**REVISED RESPONSE TO REQUEST FOR ADDITIONAL INFORMATION****APR1400 Design Certification****Korea Electric Power Corporation / Korea Hydro & Nuclear Power Co., LTD****Docket No. 52-046****RAI No.: 274-8277****SRP Section: 7.1 - Instrumentation and Controls****Application Section: 7.1, 7.3, and 10.2****Date of RAI Issue: 10/27/2015****Question No. 07.01-40**

Clarify the terms used in APR1400 FSAR Tier 2, Table 7.2-7, "Failure Mode and Effects Analysis for the Plant Protection System," Item 2-14, and clarify why an improper CEA position renders a CPC inoperable and changes the voting logic.

Figure 7.2-4 CEA Position Signal Flow for CPCS

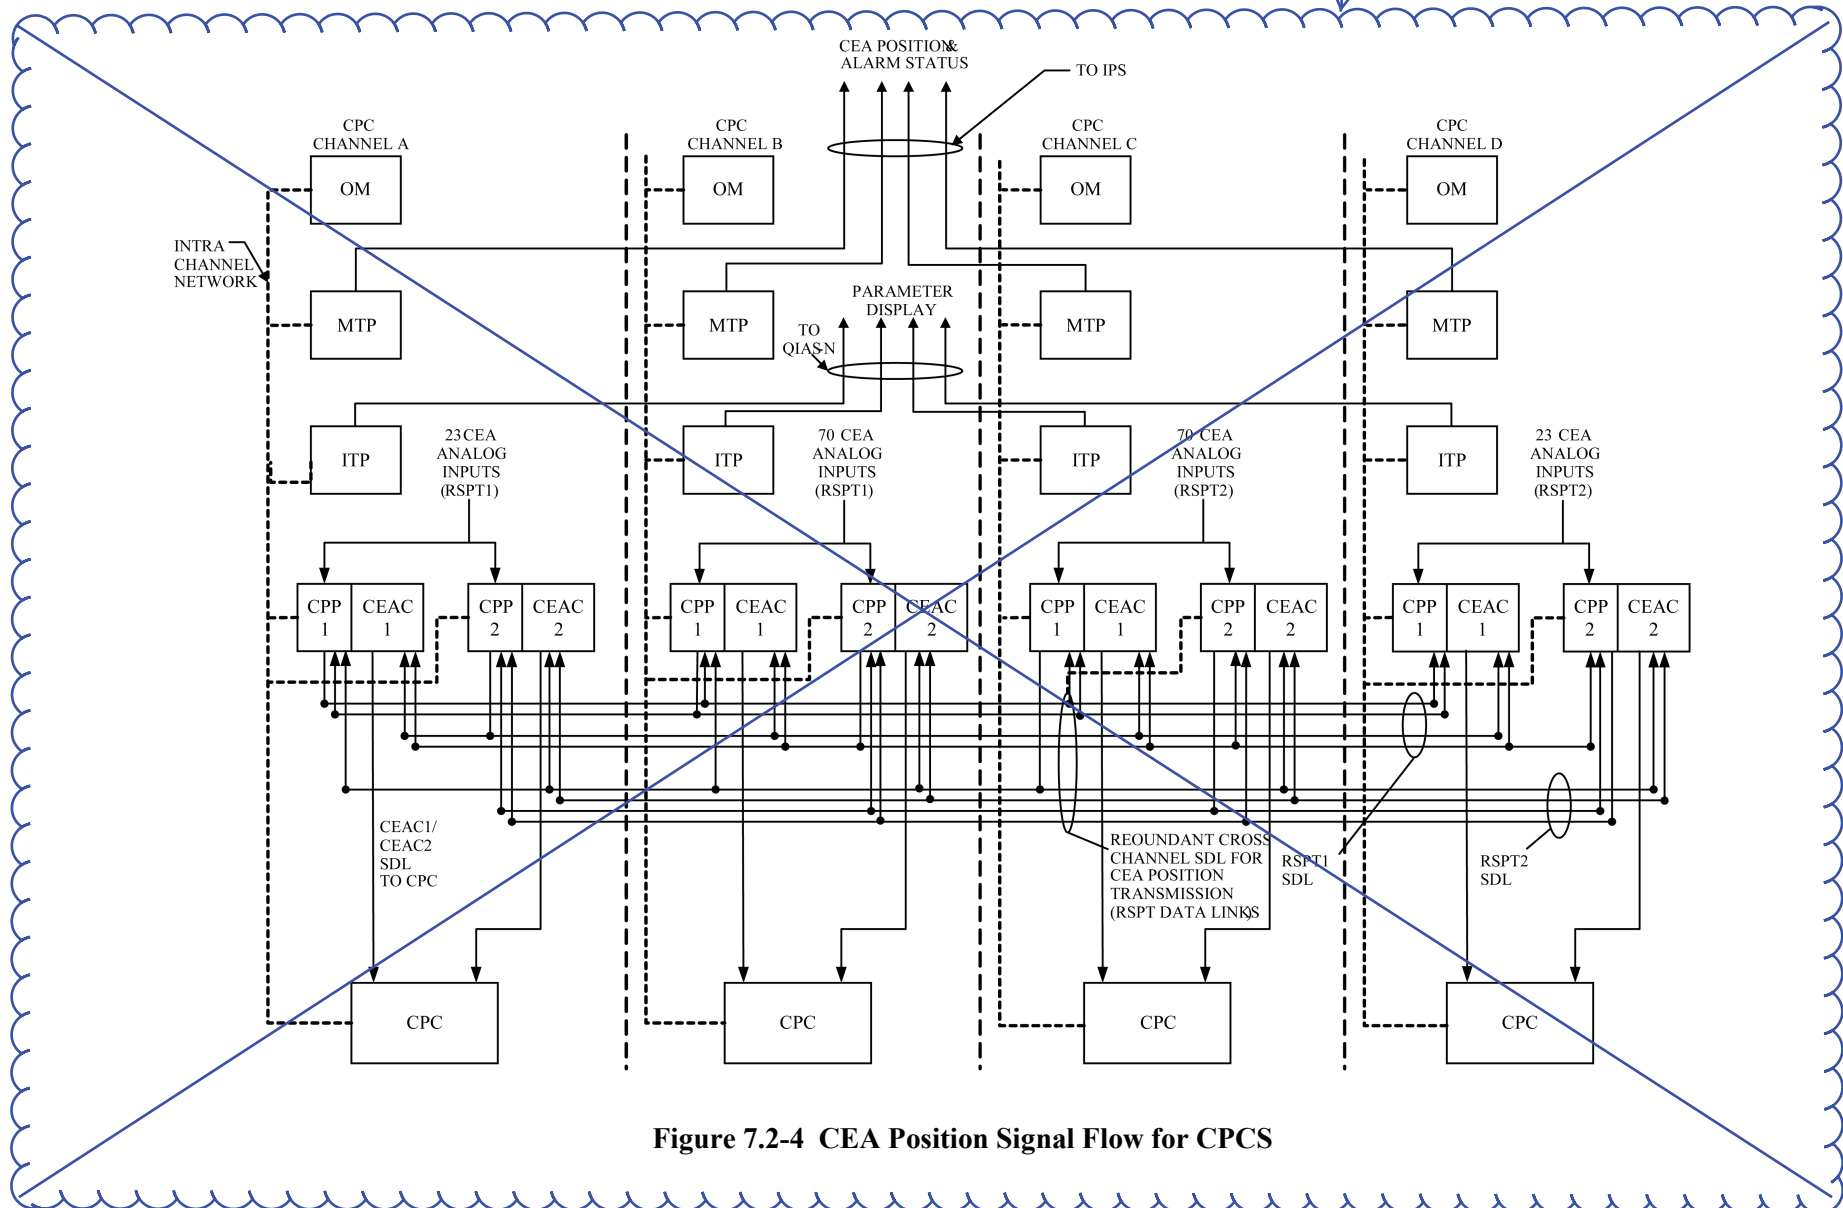
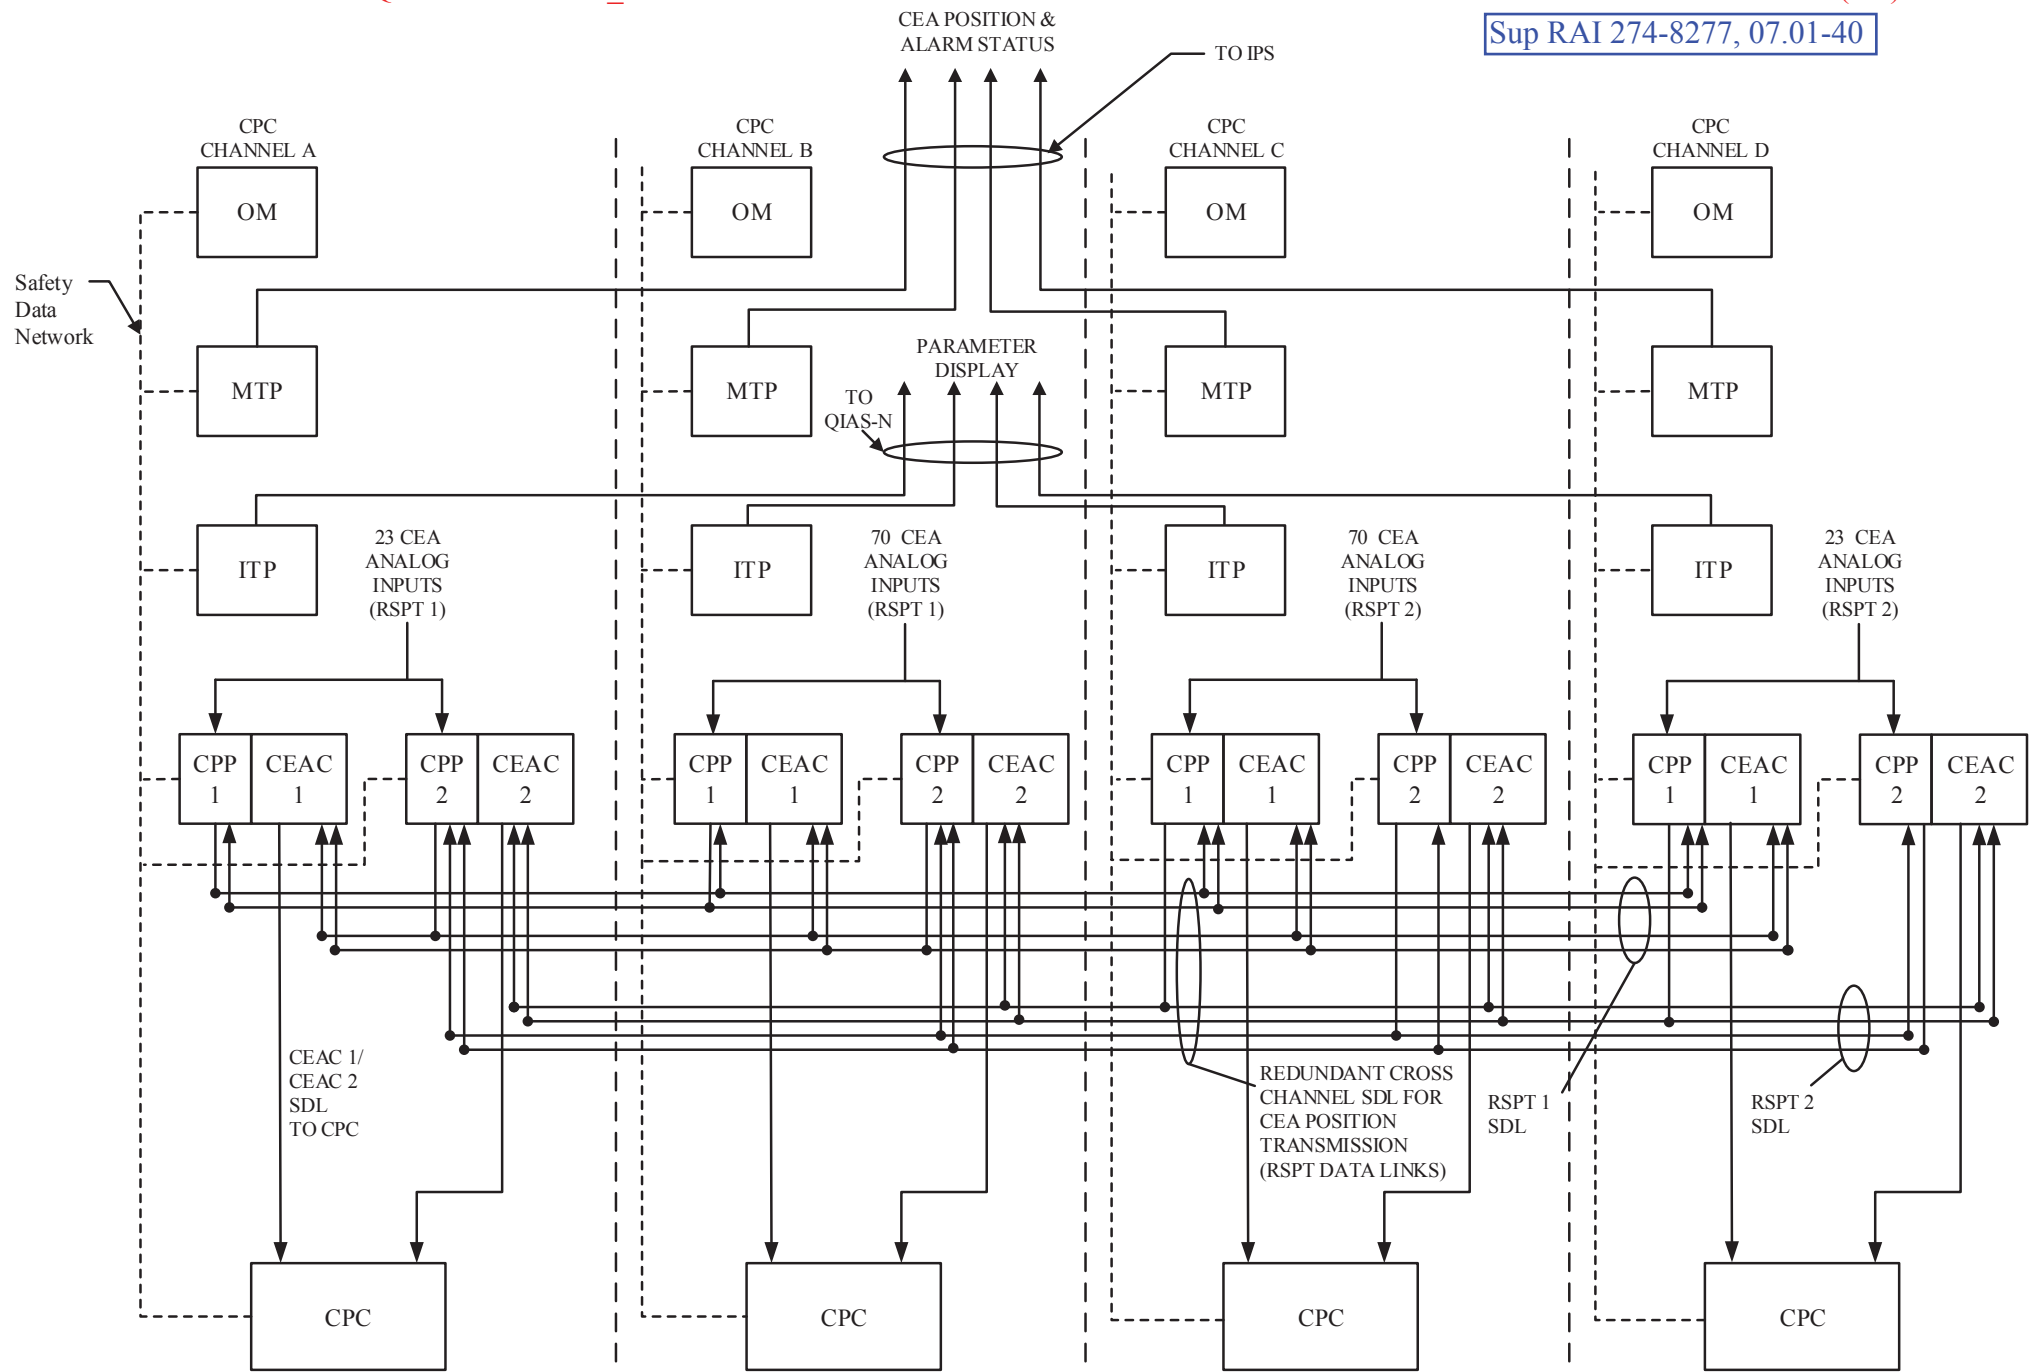
In addition, DCD Tier 2, Figure 7.2-4, “CEA Position Signal Flow for CPCS,” will be modified because it was missing a CPP output signal from the Channel D CPP1 module.

The correction made to the diagram for the input to CPP2A in this revised supplemental response also supersedes the diagram supplied in RAI 50-7911 Question 07.02-08 (ML15265A591).

The figure will be replaced with the next page.
